# BCA & DDA Capability Statement

Muswellbrook Industrial Depot  
252 Coal Road, Muswellbrook

Muswellbrook Shire Council  
c/o- CCG Architects

12 February 2025  
Reference: N240013

Figure 2: Internal Height of Class 7 Part

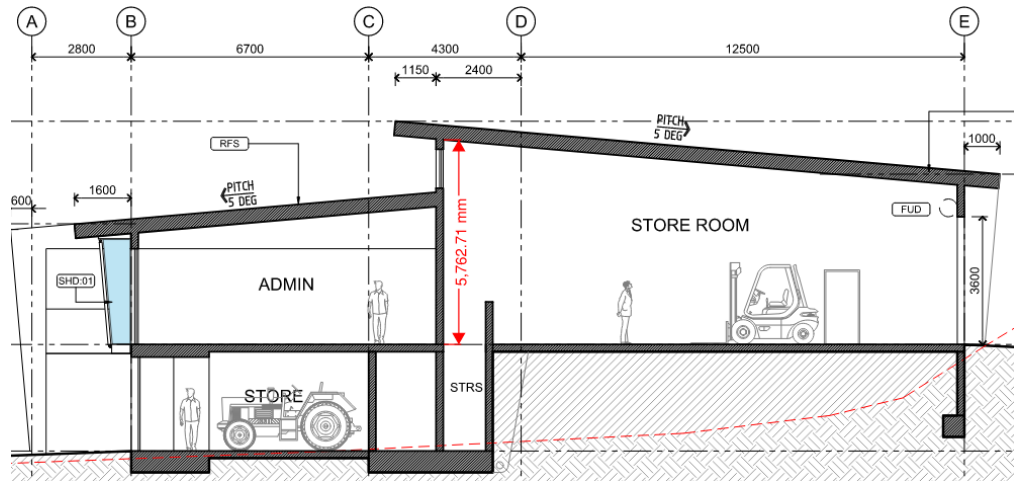
**Comment:** The building has been calculated with a Rise of Storeys of two (2) based on the finalised section drawings demonstrating an internal height of less than 6m within the Class 7 and 8 parts of the building.

Figure 3: Exposure between Separate Fire Compartments

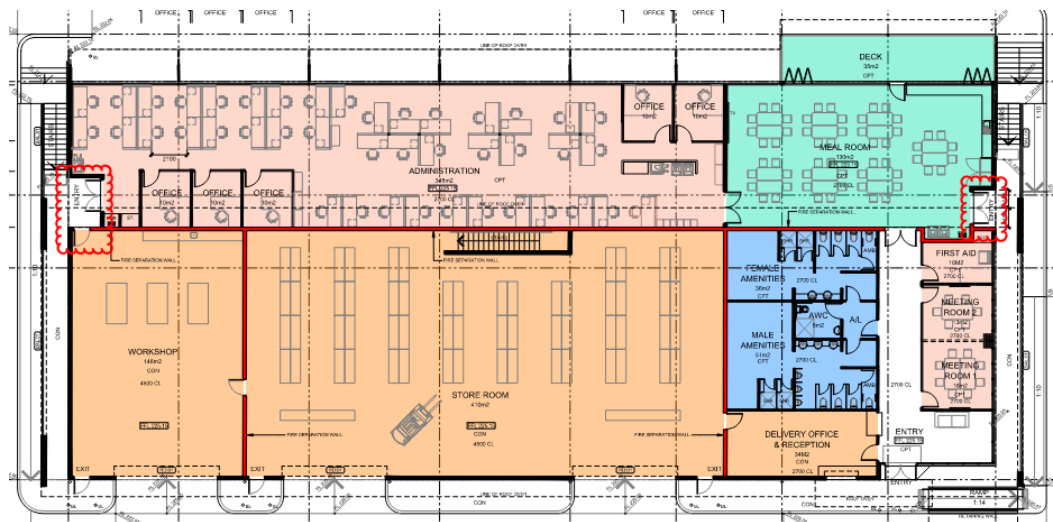
<b>C4D4 &amp; C4D5</b>	<p><b>Separation of External Walls and Associated Openings in Different Fire Compartments:</b> The distance between parts of external walls and any openings within them in different fire compartments separated by a fire wall must be at least that set out in Table C4D4 unless-</p> <ul style="list-style-type: none"> <li>+ Those parts of each wall have an FRL of at least 60/60/60; and</li> <li>+ Any openings protected in accordance with C4D5.</li> </ul> <p><b>Comment:</b> Based on the location of the proposed fire separating walls, exposure is created between adjacent fire compartments as shown in the figure below.</p>

To adequately protect the adjacent fire compartments where exposure occurs, the external walls are to be constructed to achieve an FRL of 60/60/60 where located within of the exposed fire compartment 3m at 90° and 6m where directly opposite.

Figure 4: Walls Requiring FRL 60/60/60

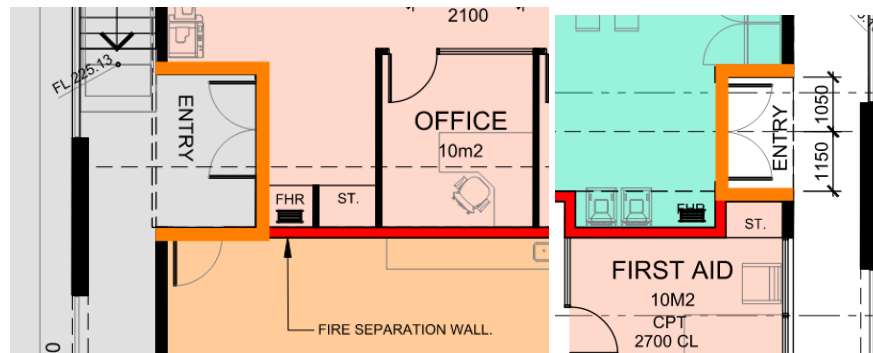
The doors contained in the required 60/60/60 walls must be protected in accordance with BCA Clause C4D5 by way of wall-wetting sprinklers to an automatic or self-closing door or, -/60/30 automatic or self-closing fire doors.

Alternatively, the exposure between adjacent fire compartments can be addressed by way of a Fire Engineered Strategy whereby the fire rating of one exposed wall achieves 120/120/120 in lieu of the two 60/60/60 walls in alternate compartments.

Figure 5: Reduced Widths in Amenities

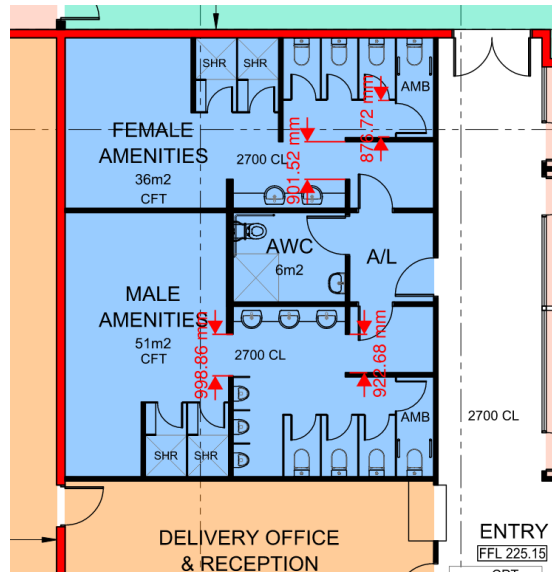
<b>D2D7/ D2D8/ D2D9/ D2D10/ D2D11</b>	<p><b>Dimensions of Paths of Travel to an Exit:</b> The minimum clear height through all egress paths is required to be no less than 2m, and a minimum of 1m wide (this width dimension is measured clear of any obstructions such as handrails and joinery) or 1.8m in a passageway, corridor or ramp normally used for the transportation of patients in beds within a treatment area.</p> <p><b>Comment:</b> Compliance is generally achieved throughout with regard to the width and height of the paths of travel to the available exits.</p> <p>Prior to application for Construction Certificate, the areas of reduced width in the amenities block and to the lower level egress path, as identified in the figures below, are to be amended or else clearly dimensioned on architectural documentation to ensure a clear width of 1m is maintained throughout.</p>

Figure 7: Western External Ramp

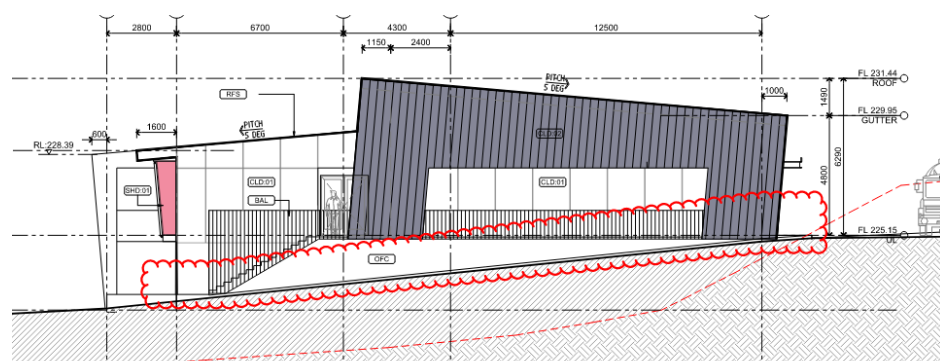
**Comment:** Compliance is readily achieved. The external ramps are understood to provide emergency egress only from the lower storey of the depot and as such achieve compliance being of gradient 1:10. The ramps are to be provided with a handrail to at least one side in accordance with the requirements of BCA Clause D3D22.

Updated architectural documentation will need to be provided along with the application for Construction Certificate showing construction details as applicable to the ramps.

Figure 9: Door Swing Impeding on the Minimum Exit Width

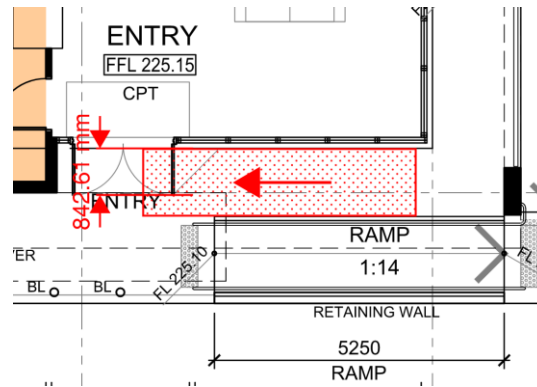
The design is to be amended to ensure the outward swing of the required exit doors does not encroach on the minimum width of a path of travel by more than 500mm.

Figure 10: Lower Level Compartment Area

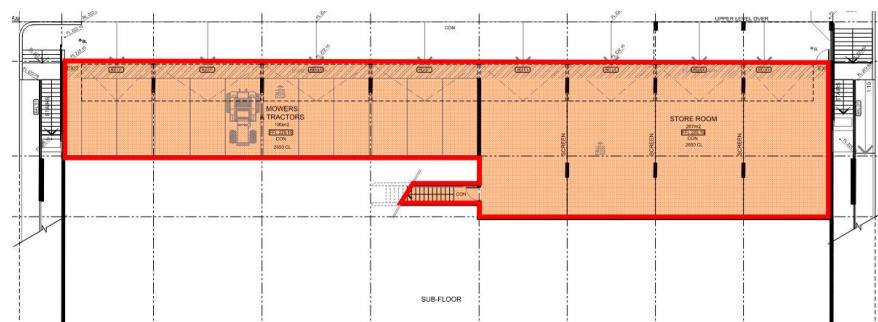
The fire hose reel system is to be extended to serve the two storey, Class 7 fire compartment where the upper level store room is connected to the lower level store room and car park having a combined floor area of 867m<sup>2</sup>.

Figure 12: Indicative Swing of Cupboard Door

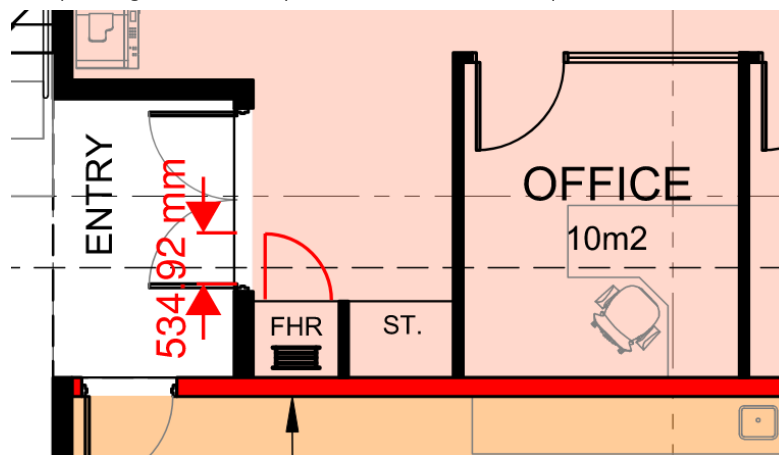
Where the fire hose reels are to be enclosed in a designated cupboard, no debris or equipment is to be stored within the space and the design is to ensure the opened cupboard door does not impede on the required egress width by more than 500mm as per BCA Clause D3D25.

Figure 13: Proposed Accessway

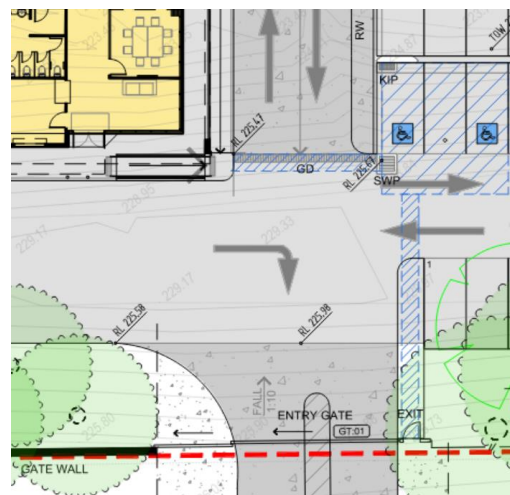
**Comment:** An accessible path of travel appears to be provided connecting the principle pedestrian entry to the allotment boundary and the designated accessible car parking bays. Adequate wayfinding signage and accessible installations are to be provided along the nominated accessway.

Additional details are to be submitted along with application for Construction Certificate confirming compliant grades are achieved, kerb ramps and TGSIs are provided and safety movement through carparking areas can be achieved.

Figure 14: Inadequate Passing Space where Line of Sight is Broken

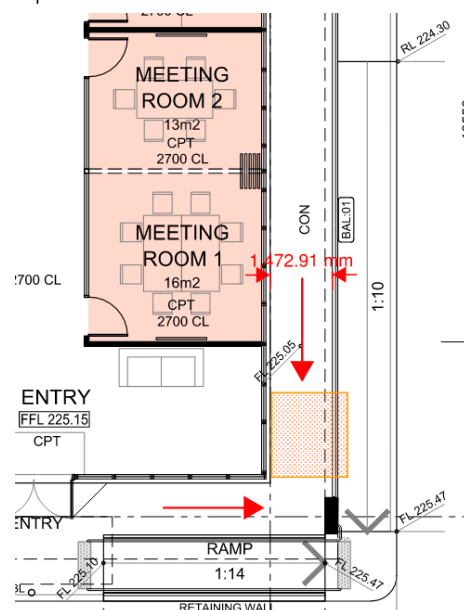
Where direct line of sight cannot be maintained for the complete length of the external balcony, adequate turning space of 1800mm x 2000mm. It is to be confirmed if this external accessway is proposed to be an accessible path of travel.

Figure 15: Inadequate 90° Turning Space

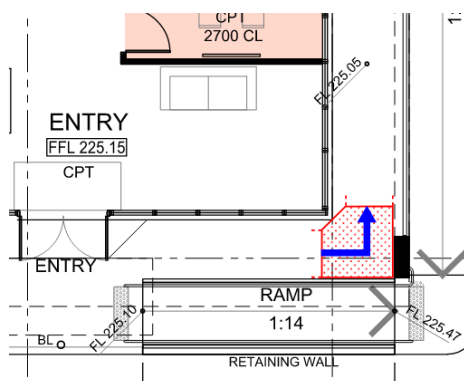
The design is to ensure adequate turning space is provided on accessible paths of travel. Where an accessway requires a 90° turn, an unobstructed space of 1500mm x 1500mm, with permitted internal splay, is to be provided to enable unimpeded operation of a mobility aid. The external balcony area identified in the figure below is to be addressed where this is considered an accessible path of travel.

Figure 16: Furnishing in Door Circulation Space

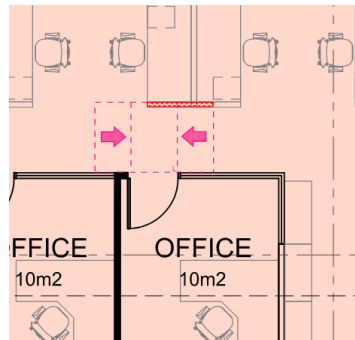
Consideration for turning and circulation space should also be made with respect to any fixed furnishings or those that cannot be readily moved by a building occupant i.e. stacks, filing cabinets, desks etc. See below typical examples of circulation spaces being impeded by proposed furnishings, it is to be confirmed if these items are proposed to be readily moveable.

Figure 18: Constantina Doors

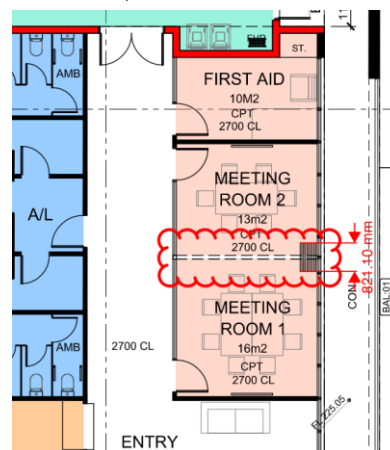
The clear opening width of an accessible door leaf is to be not less than 850mm. It is to be confirmed how this will be achieved by the proposed constantina door system. Additionally, the system is to be provided compliant door hardware, operating forces, circulation space etc. as applicable to all doors within accessible spaces.

Figure 19: Impeded Door Circulation

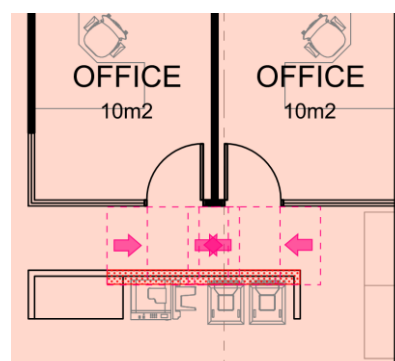
Clear circulation space is to be provided to both sides of a swinging door within an area required to be accessible in accordance with Figure 31. The required circulation space serving doors to the offices identified in the figure below are shown to be obstructed by proposed joinery elements. This is to be amended to ensure a clearance of 1670mm from the surface of the wall is maintained as required for a dual approach.

Figure 20: Non-Accessible Doors

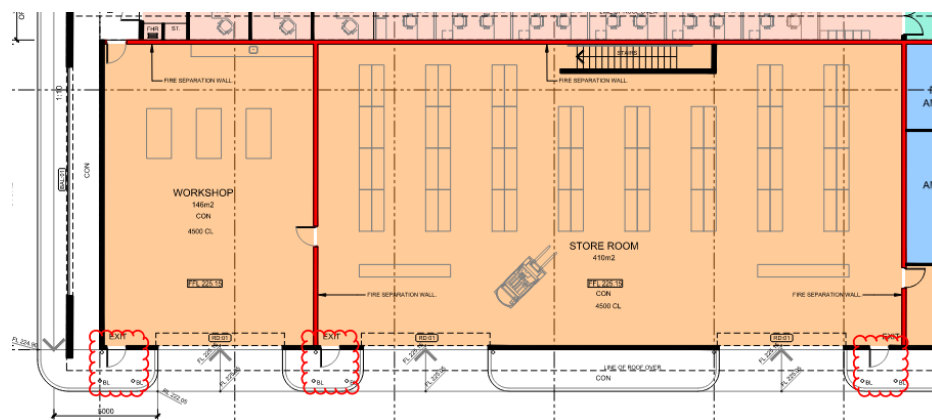
Similarly, the required circulation space to the external doors serving the Class 7 and 8 parts of the upper level is encroached upon by the protective bollards. However, it is understood that these areas are exempt from being accessible and therefore compliance is achieved.

Figure 21: Accessible Ramp

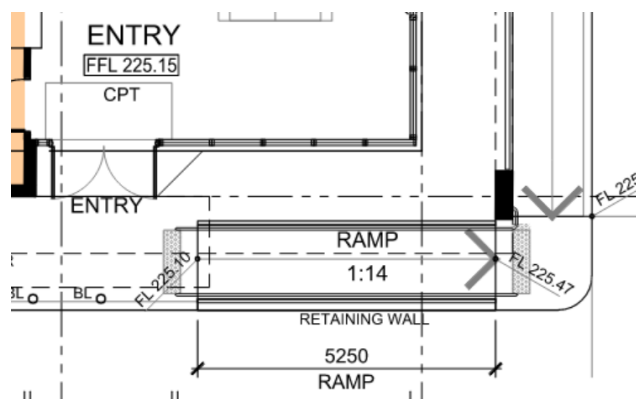
**Comment:** Compliance is readily achieved. Based on the architectural documentation, a compliant accessible ramp and associated features is proposed to be provided between the building and the accessible car parking bays.

The external ramps serving the lower level do not achieve compliant grades with the requirements of this clause and AS1428.1-2009, however it is understood that this area is proposed to be exempt from access and the ramps serve for egress purposes only.
